# Technical Service Bulletin

## 64 Squeaking noises during window operation

64 13 28 2034955/1 August 12, 2013.

Figure 1. Front door window guide seal.

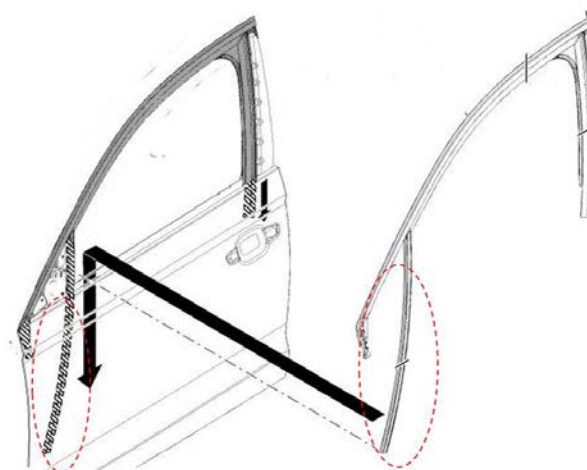
If the squeaking noises are coming from the window guide, check the installation of the window guide seal (Figure 1).

**Figure 2.** An incorrectly-fitted guide seal (1) and a correctly-fitted guide seal (2).

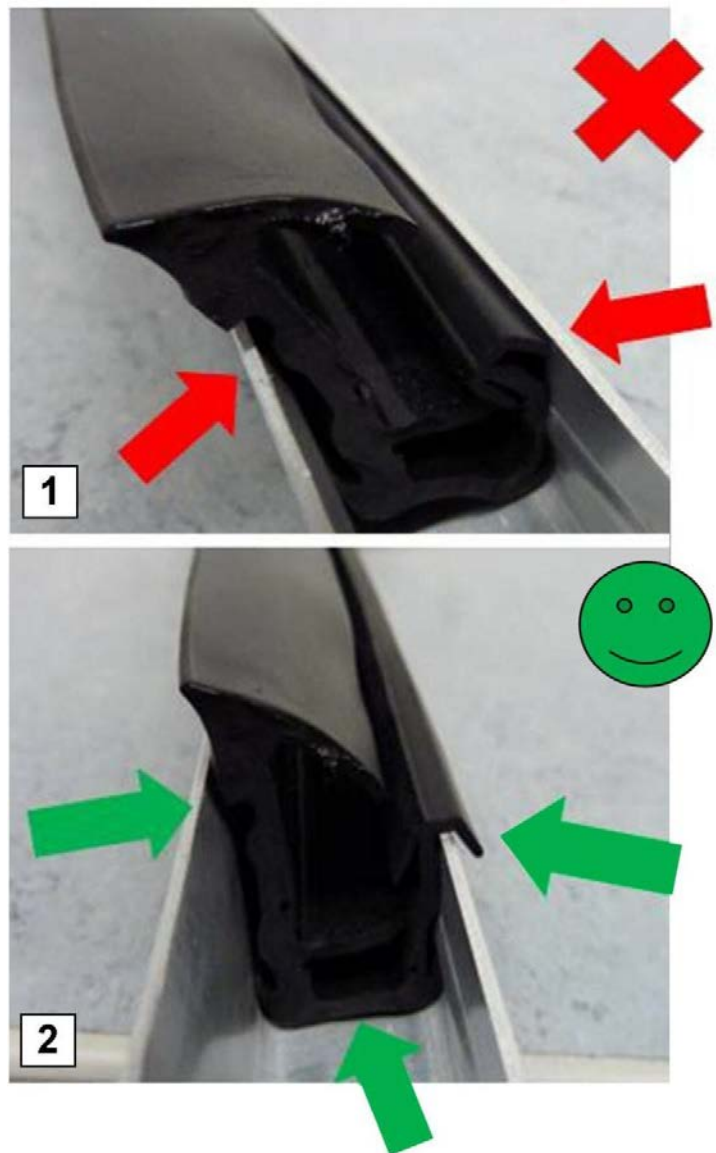
- The window guide seal might not be correctly positioned in the guide, so the support lips are pushed into the guide (Figure 2, 1). As a result, the pressure of the guide seal on the window is increased.

Ensure that the window guide seal is correctly positioned in the guide (Figure 2, 2).

**Figure 3.** An incorrectly-installed guide seal (1) and a correctly-installed guide seal (2).

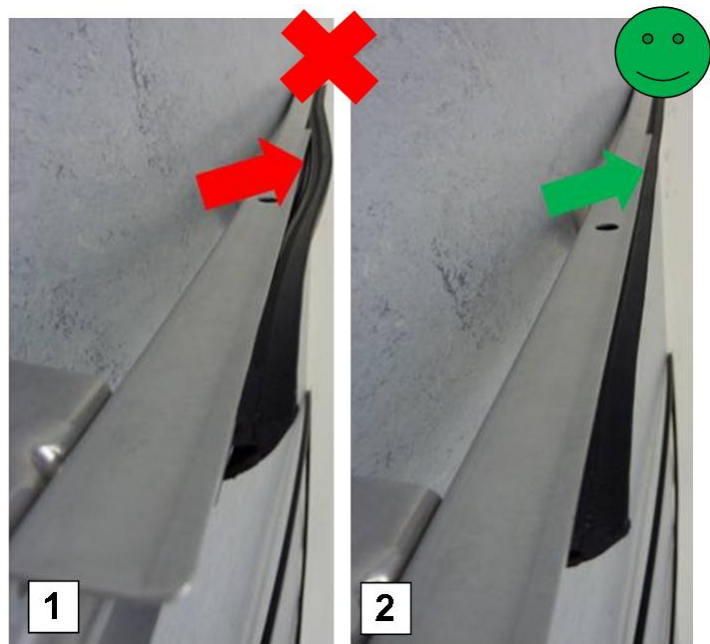
- The window guide seal might not be installed across the complete length of the guide (Figure 3, 1).

Ensure that the window guide seal is installed across the complete length of the guide (Figure 3, 2).
